RECEIPT DATE: 11-19-25 **ONSITE SEWAGE DISPOSAL SYSTEM** P 590281

APPROVAL DATE: 1/15/26 **PERMIT: NEW CONSTRUCTION** A _____

PROPERTY ADDRESS: 857 Morgan Station Road

857 MORGAN STATION ROAD
 WOODBINE, MD 21797
 LOT 2, PLAT 18989, MAP 8
 GRID 2, 48,494SF, ACCT#04-593623
 ONSITE SEWAGE DISPOSAL
 SYSTEM DESIGN PLAN

- SOILS INFORMATION TAKEN FROM USDA WEB SOIL SURVEY WEBSITE
 NOTE: HIGHLY ERODIBLE SOILS ARE THOSE SOILS WITH A SLOPE GREATER THAN 1% OR THOSE SOILS WITH A SOIL ERODIBILITY FACTOR 1% GREATER THAN 0.36 WITH A SLOPE GREATER THAN 5 PERCENT.

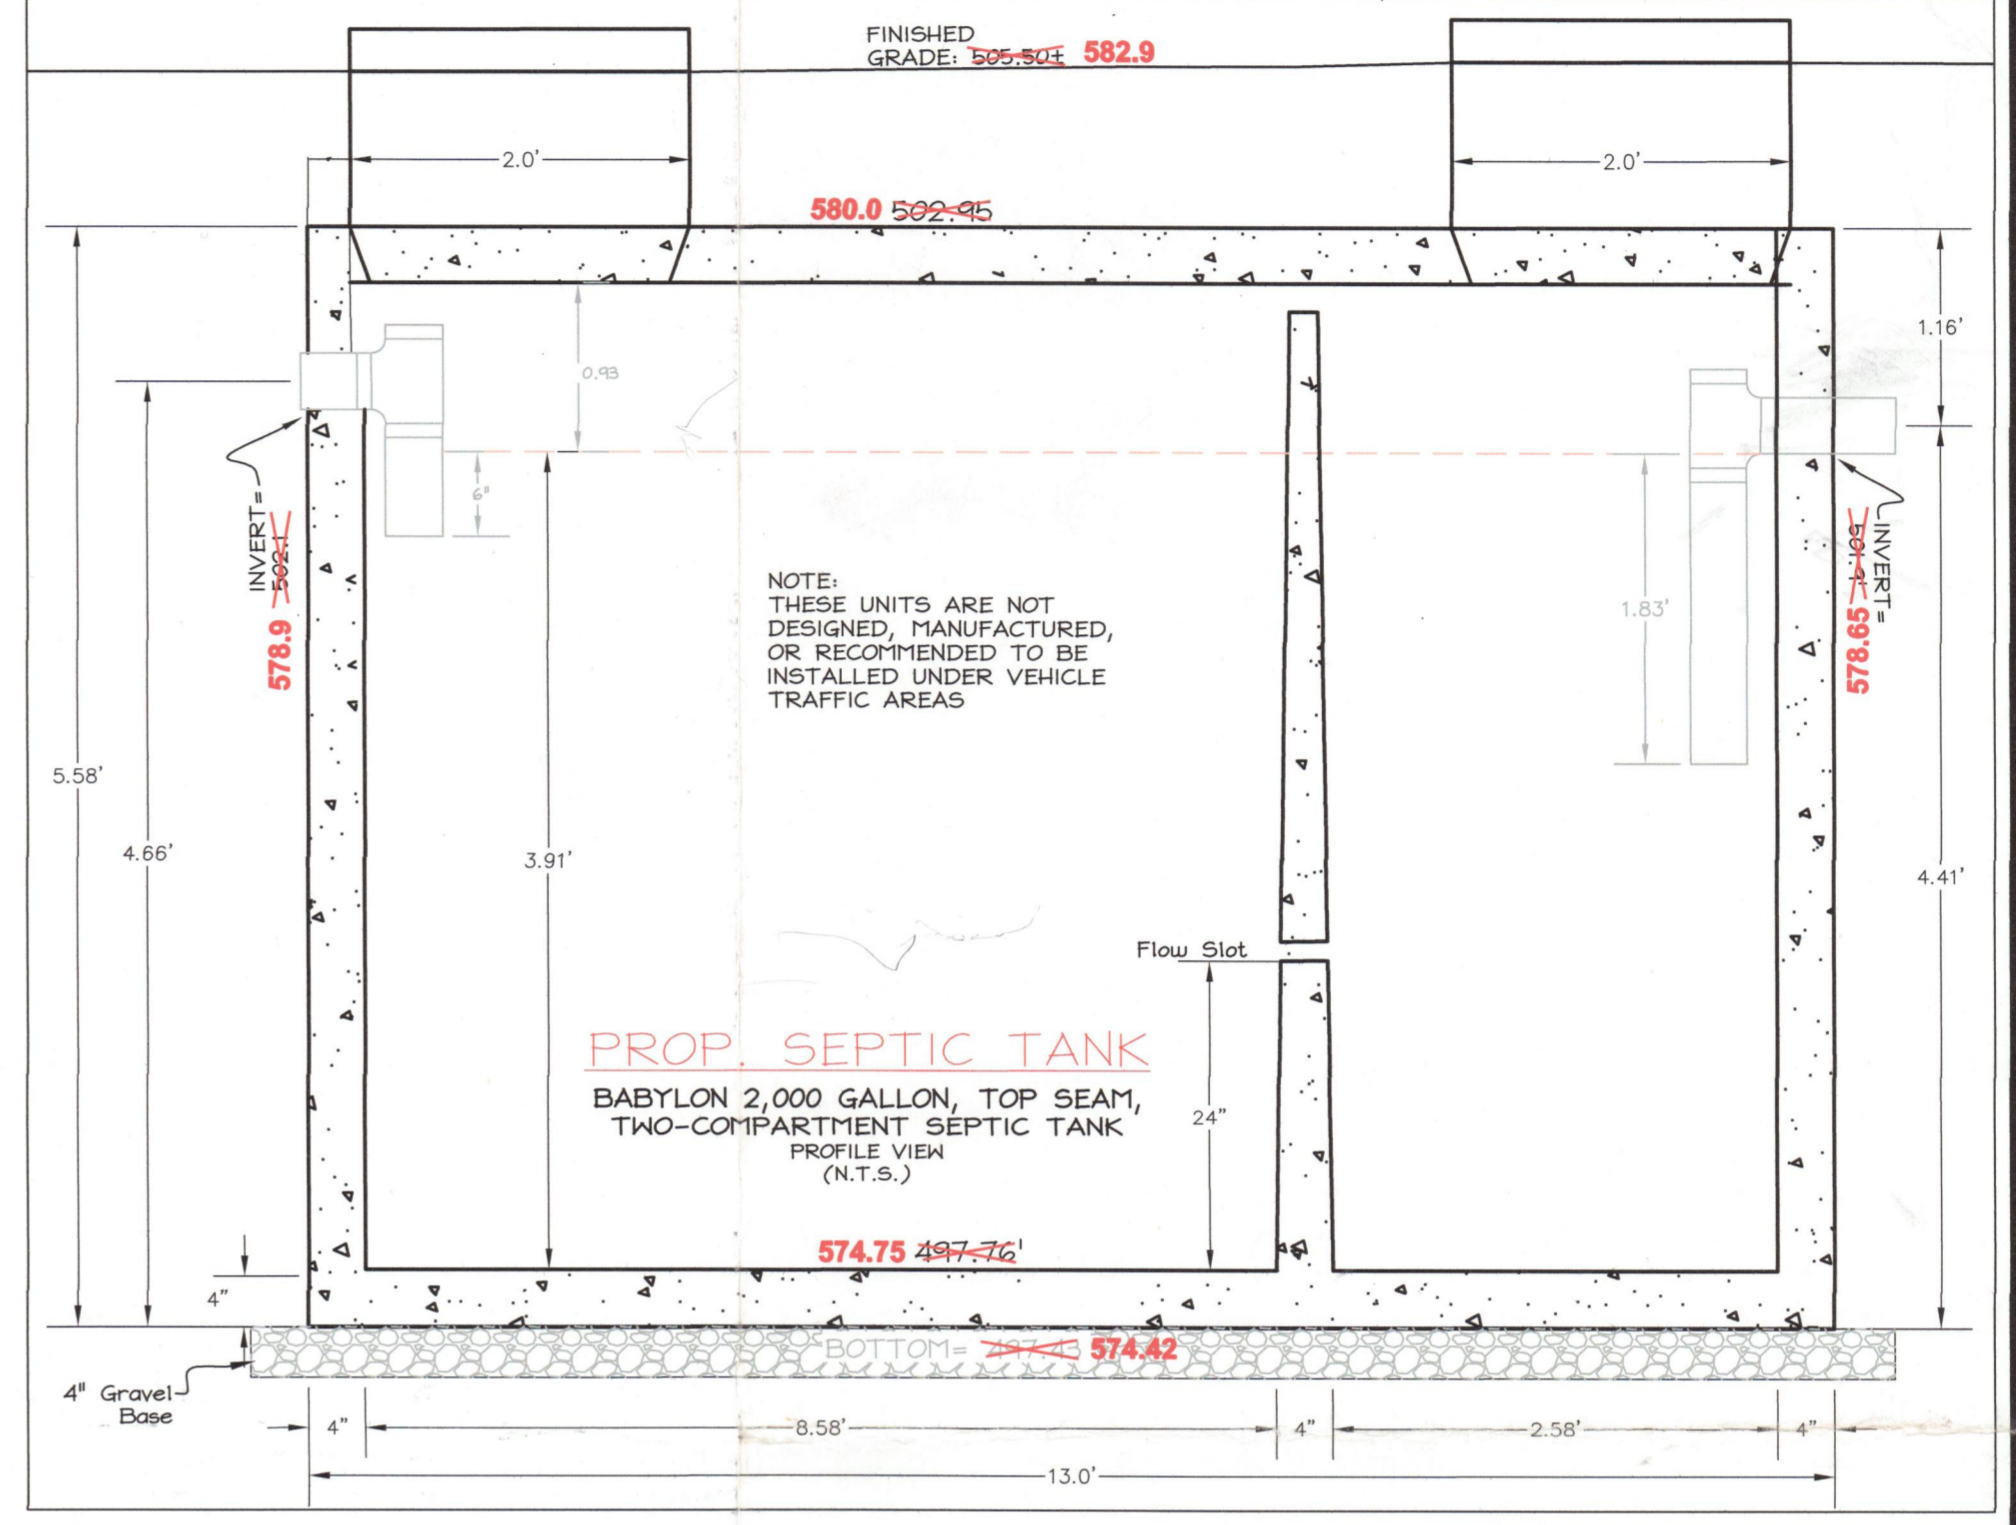
1. **The septic contractor made it seem like the main septic line leaving the house was under the “enclosed porch.” Is your redline piping accurate and we do know that the invert out of the house is 580.4’ and coming out of the house at that location?**
 - a. **Can you provide that confirmed invert depth on the septic profile as well.**
2. **For the initial system, all of the invert depths should be at 3’ for all four of the trench lines.**
3. **For the 2nd reserve system, all of the invert depths should be at 2’.**
4. **ON septic system profile it says 1500 GAL tank, should state 2000 GAL.**
5. **Add a general note that states, “When the 2nd reserve septic system is required to be installed, a pump chamber will be required and an updated OSDS plan with all required details and pump calculations must be provided to the Health Department for approval.”**

This is the plan I just left a message about. They are about 1-foot low at the top trenches. They wanted to use the 1st reserve system now to avoid installing a pump. If/when the first system fails they could go to the second reserve or install a pump at that time. Please let me know if this would work.

- ALL WELLS SHOWN ON THIS PLAN HAVE BEEN FIELD LOCATED AND ARE ACCURATELY SHOWN.
- When the 2nd reserve system is required to be installed, a pump chamber will be required and an updated OSDS plan with all required details and pump calculations must be provided to the Health Department for approval.

ONSITE SEWAGE DISPOSAL DESIGN PLAN

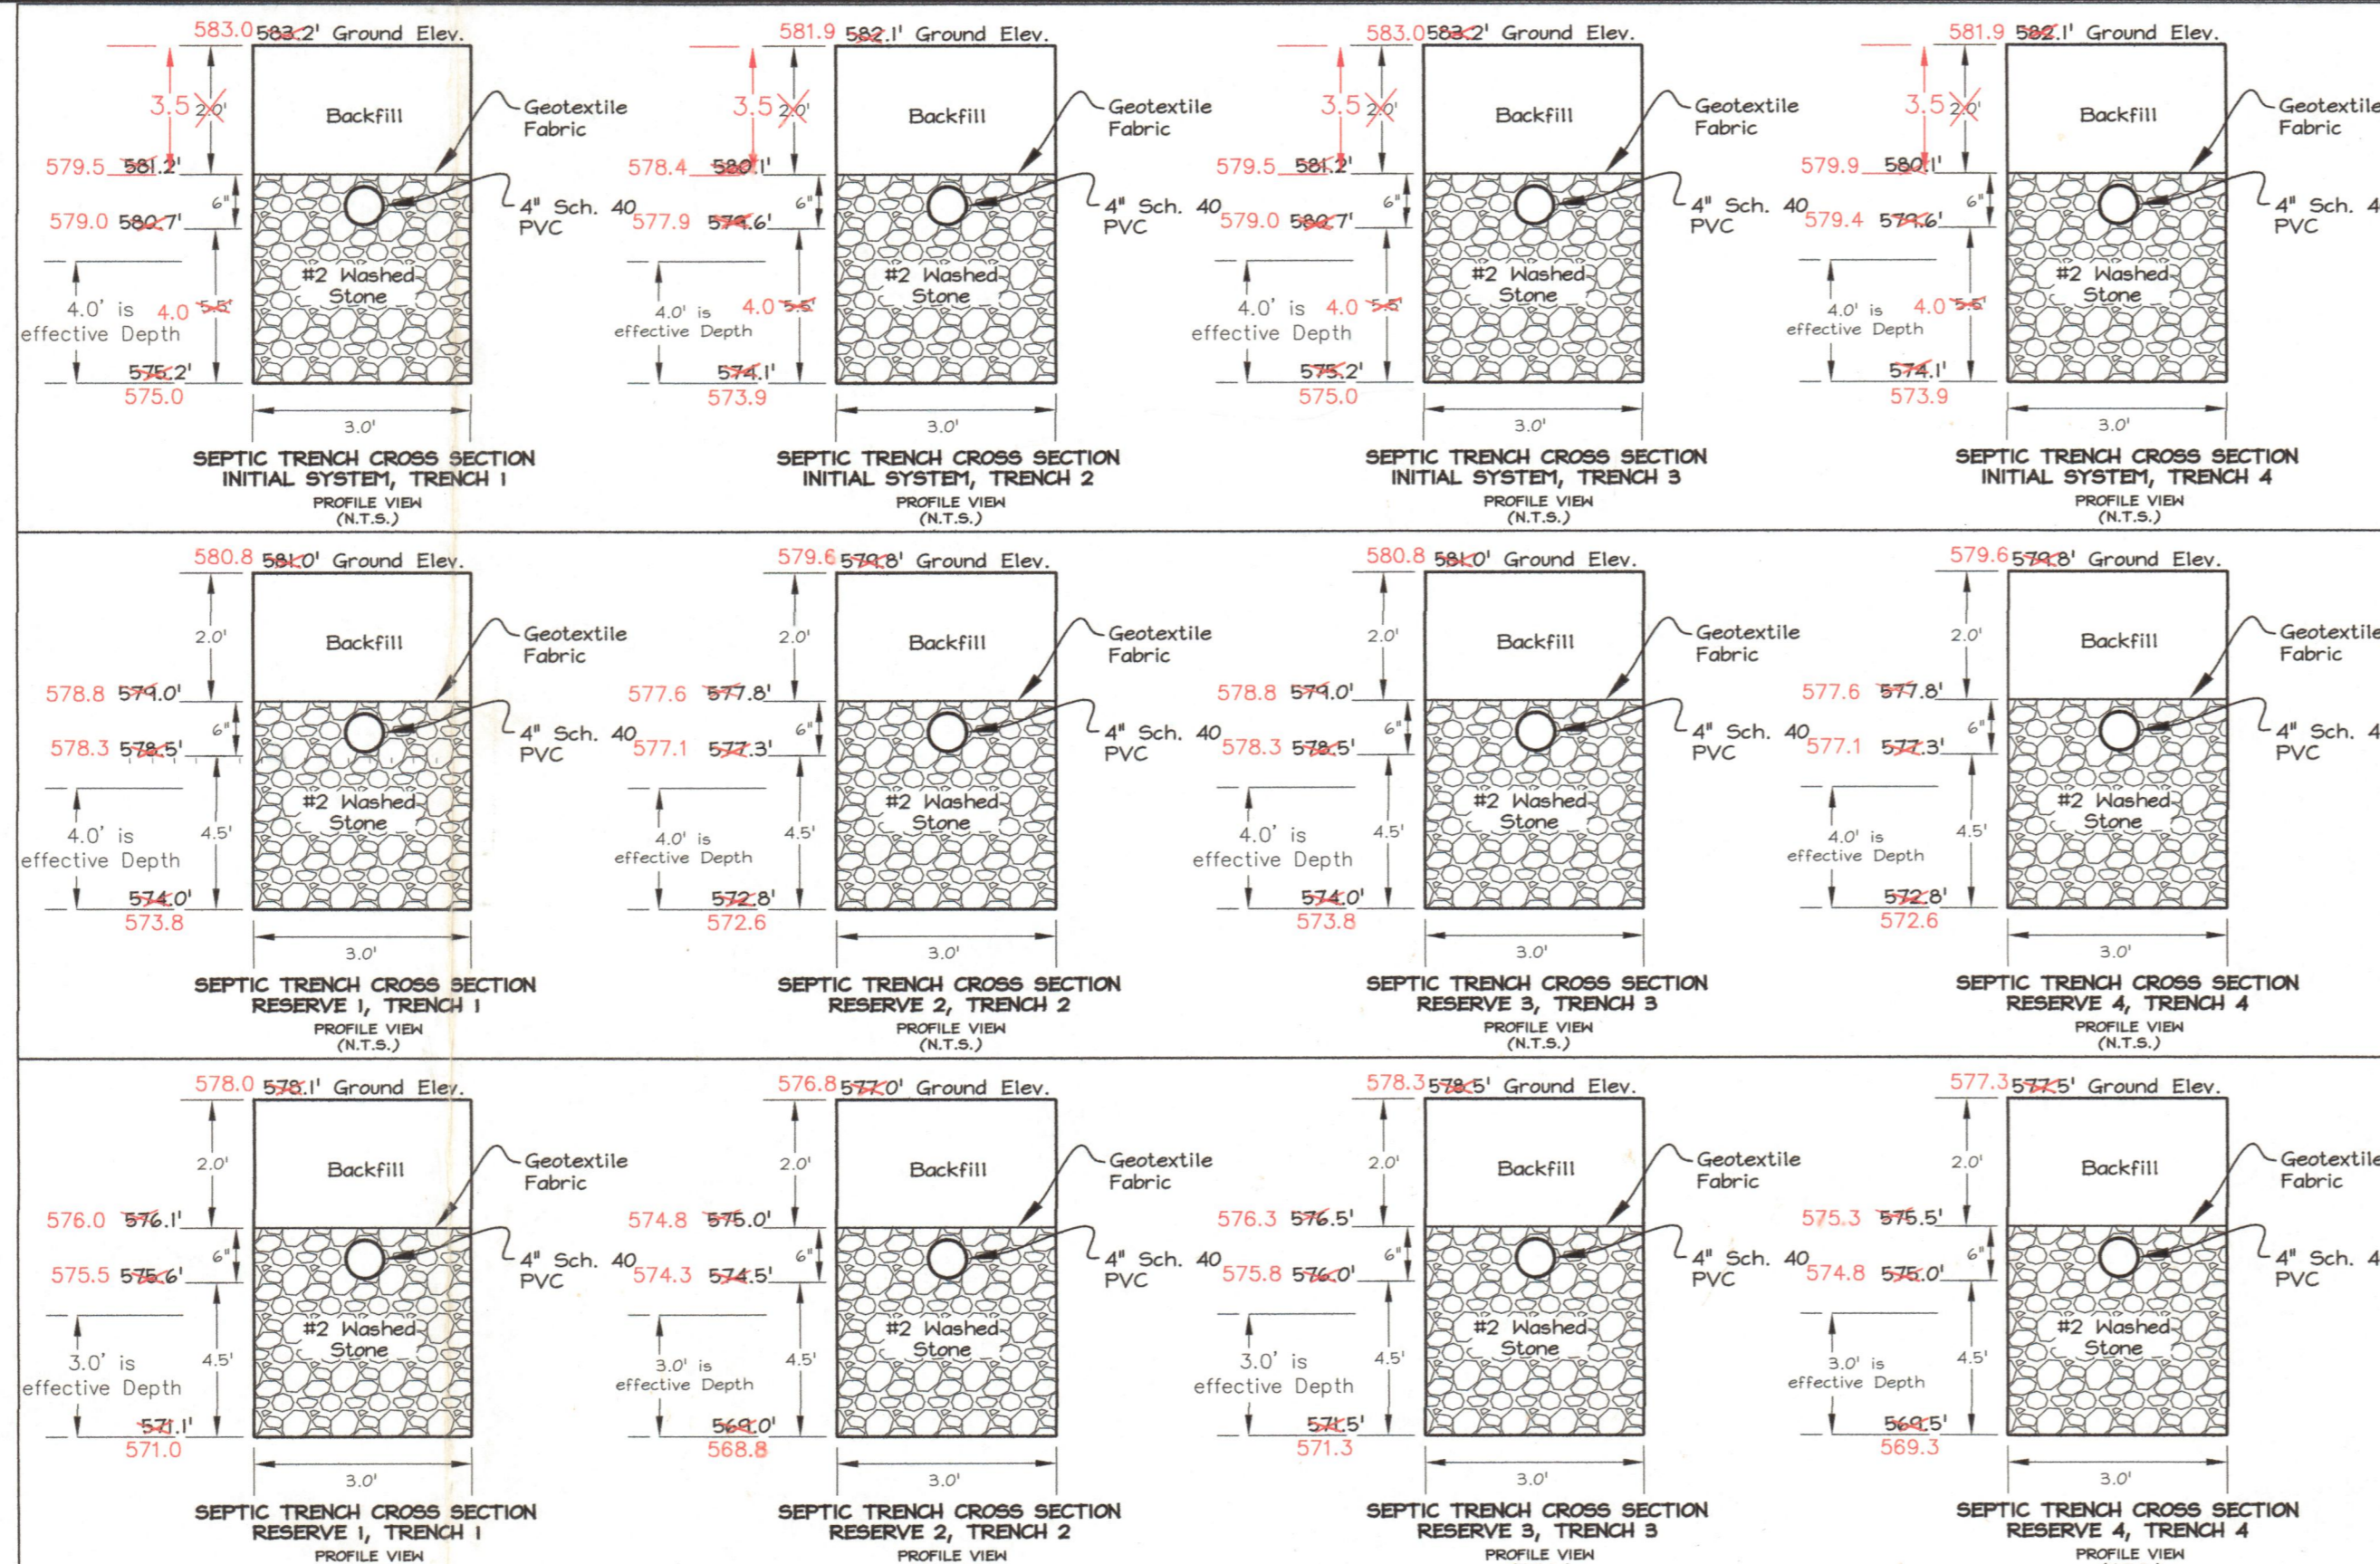
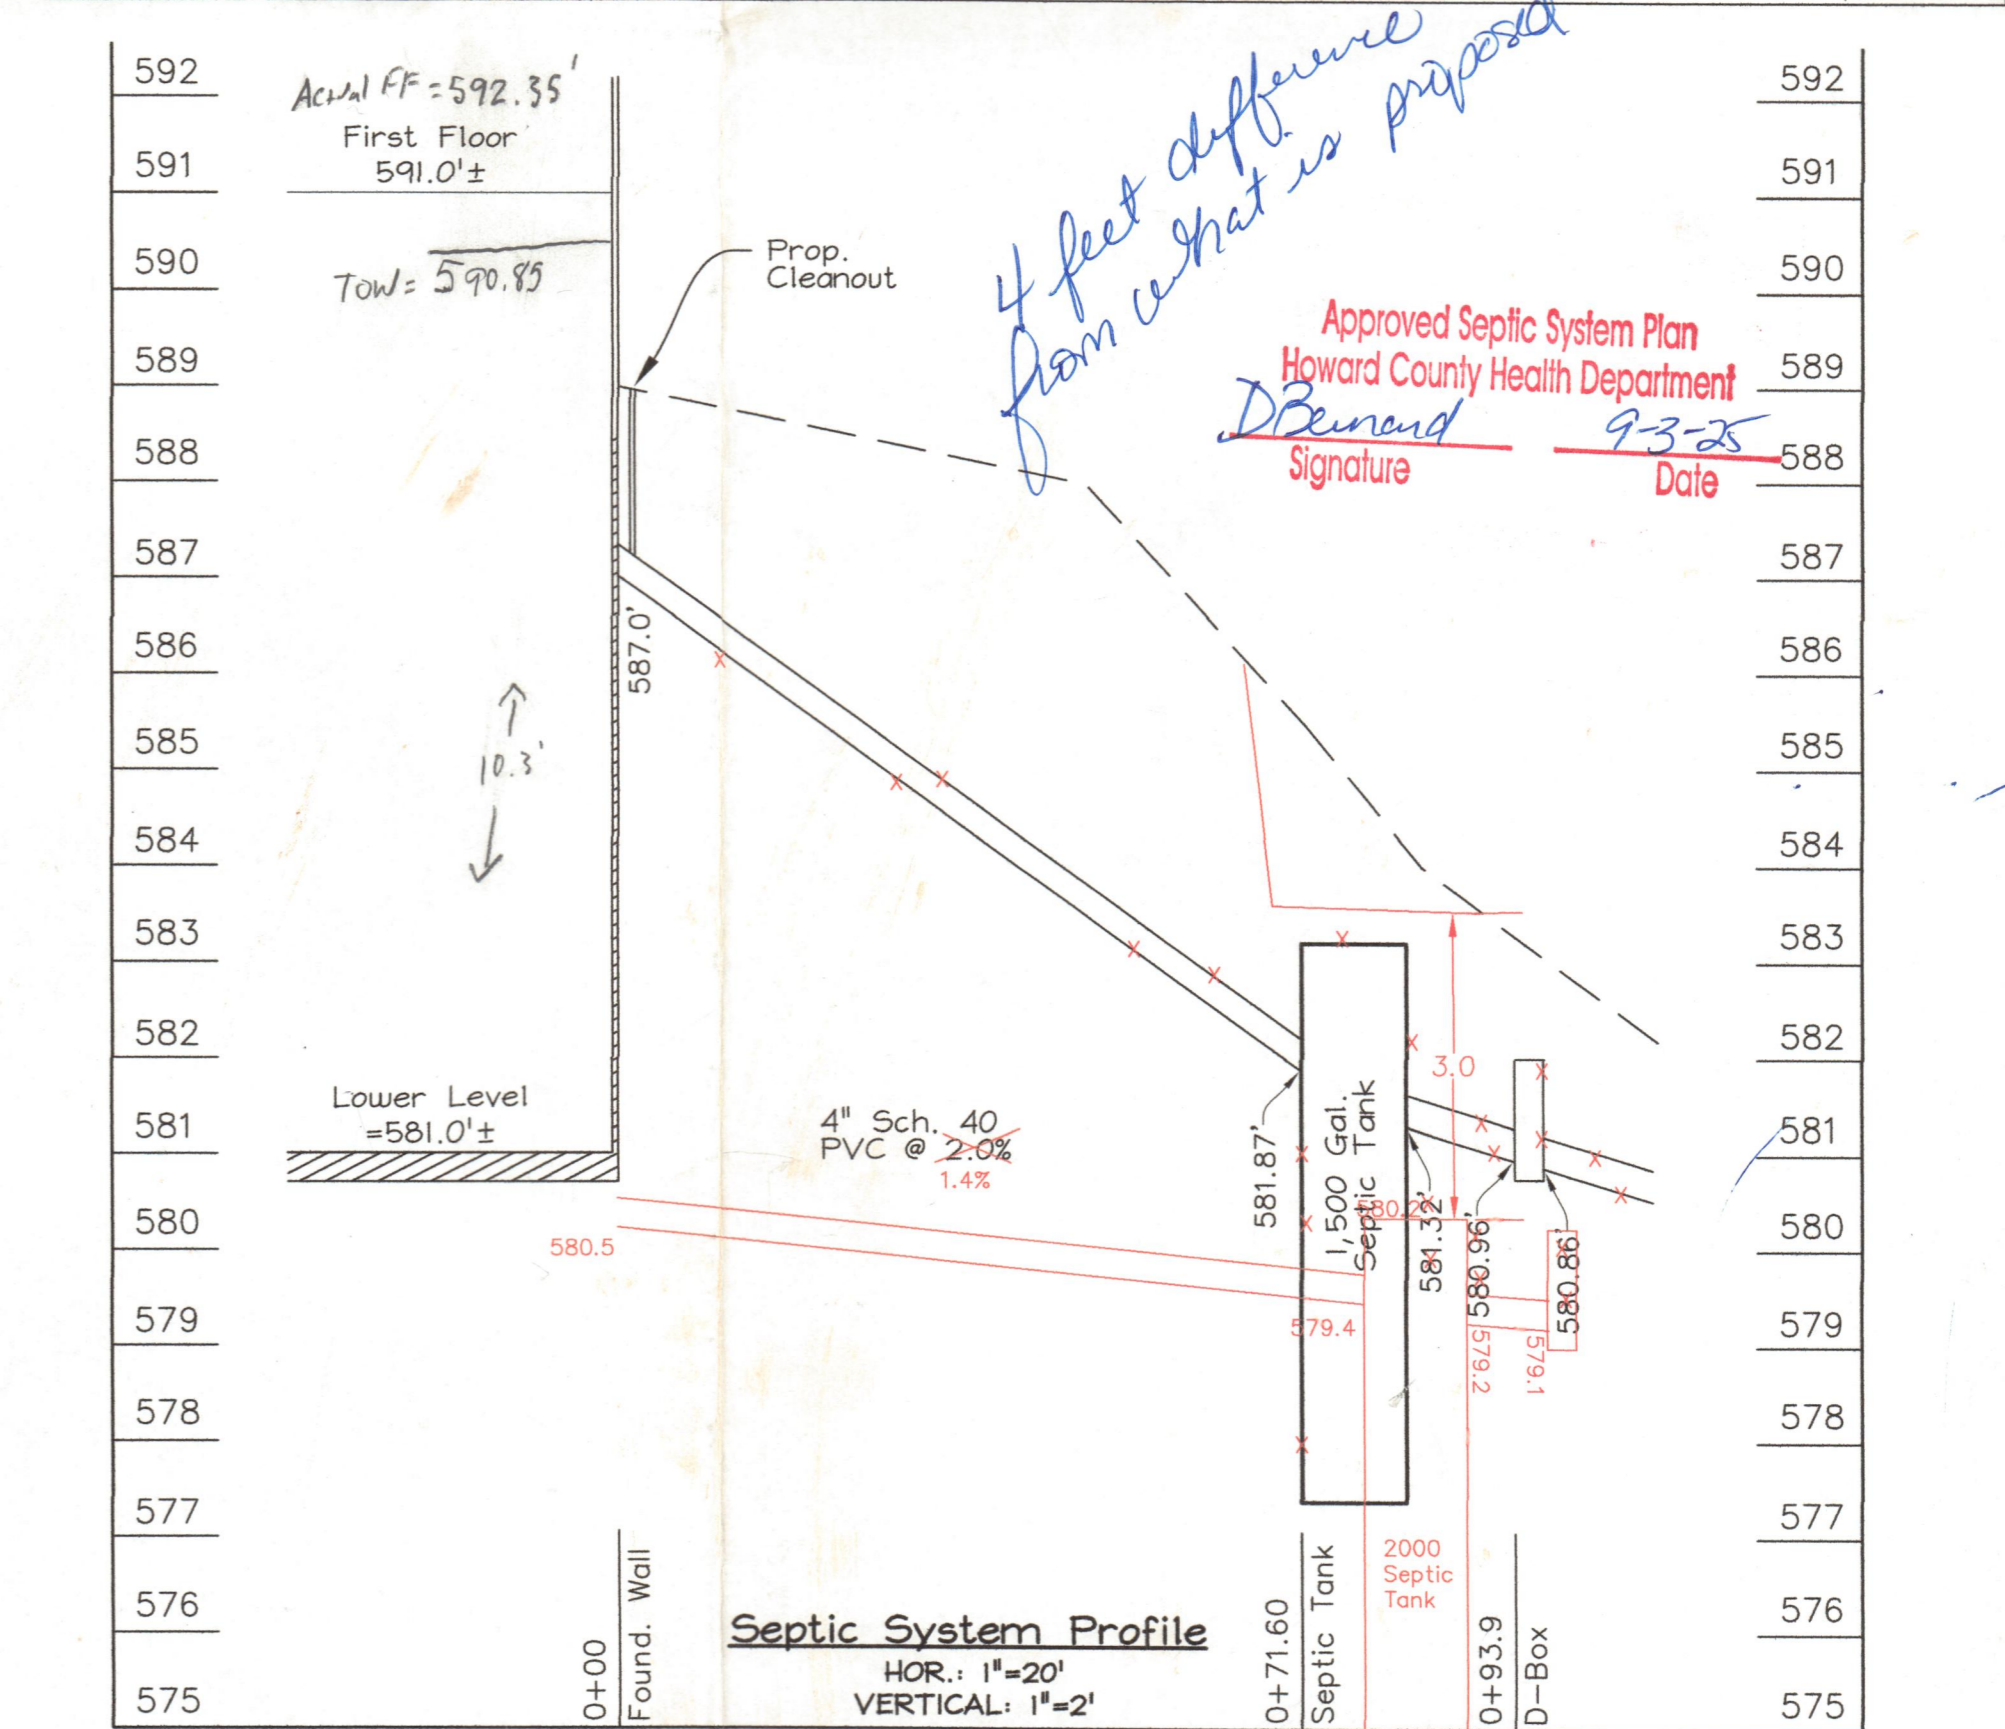
1. **Need to update the plan to reflect a 2000 GAL tank on the plot plan, on the tank detail, and on the septic profile.**
2. **Need all trenches to be 13' apart due to 5' of sidewall credit. [W +D(2)]**
3. **You could put a 22.5 or 45 degree bend in some of the system trenches to get them on contour better. (overall not bad tho)**
4. **Still need to show perc holes & elevations on OSDS.**
5. **Provide exact square footage of well box and SDA.**
6. **Need an updated Perc Cert if changing the well box for Lot 2.**

- A new revised percolation certification plan must be submitted prior to the submission of the OSDS. There have been several changes to this subdivision and the location of the well box has changed on the OSDS submitted.
- When you submit your revised OSDS to reflect your PC please make sure the trenches are on contour.
- The OSDS proposal for your plan shows a 1500-gallon tank and you are proposing a house with 6 bedrooms. You must accommodate the number of bedrooms proposed with a 2000-gallon tank. Please revise.
- The revised PC must match OSDS.
